Project	IEEE 802.16 Broadband Wireless Access Working Group < http://ieee802.org/16 >	
Title	Comments on Randomization for IEEE P802.16m/D1 (15.3.12.2.6)	
Date Submitted	2009-08-28	
Source(s)	Yih-Guang Jan, Yang-Han Lee, Hsien-Wei Tseng, Ming-Hsueh Chuang, Jheng-Yao Lin Tamkang University (TKU)	yihjan@yahoo.com
	Youn-Tai Lee, Chun-Yen Hsu Institute for Information Industry (III)	lyt@nmi.iii.org.tw
	Shiann-Tsong Sheu National Central University (NCU)	stsheu@ce.ncu.edu.tw
	Whai-En Chen National Ilan University (NIU)	wechen@niu.edu.tw
	Shiunn-Jang Chern National Sun Yat-sen University(NSYSU)	chern@mail.ee.nsysu.edu.tw
Re:	IEEE 802.16 Working Group Letter Ballot #30: P802.16m/D1	
Abstract	Comments on Randomization for IEEE P802.16m/D1 (15.3.12.2.6)	
Purpose	To be discussed and adopted by TGM for IEEE P802.16m/D1.	
Notice	<i>This document does not represent the agreed views of the IEEE 802.16 Working Group or any of its subgroups. It represents only the views of the participants listed in the "Source(s)" field above. It is offered as a basis for discussion. It is not binding on the contributor(s), who reserve(s) the right to add, amend or withdraw material contained herein.</i>

Comment

Figure 492- The Data randomization with a PRBS generator $(1+x^{18}+x^{23})$

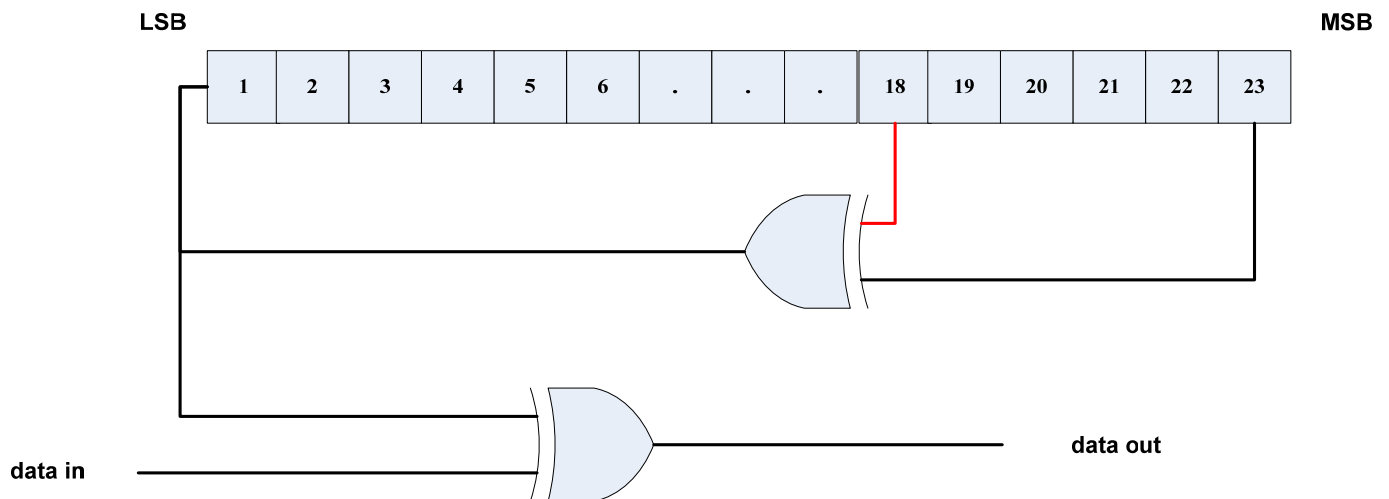
This contribution provides the corrected figure in the description of Data Randomizer in Channel Coding. It has an error in the depict of ‘Data Randomizer’ in Figure 492.

[In IEEE P80216m/D1, Section 15.3.12.2.6, replace Figure 492 by the following corrected figure]
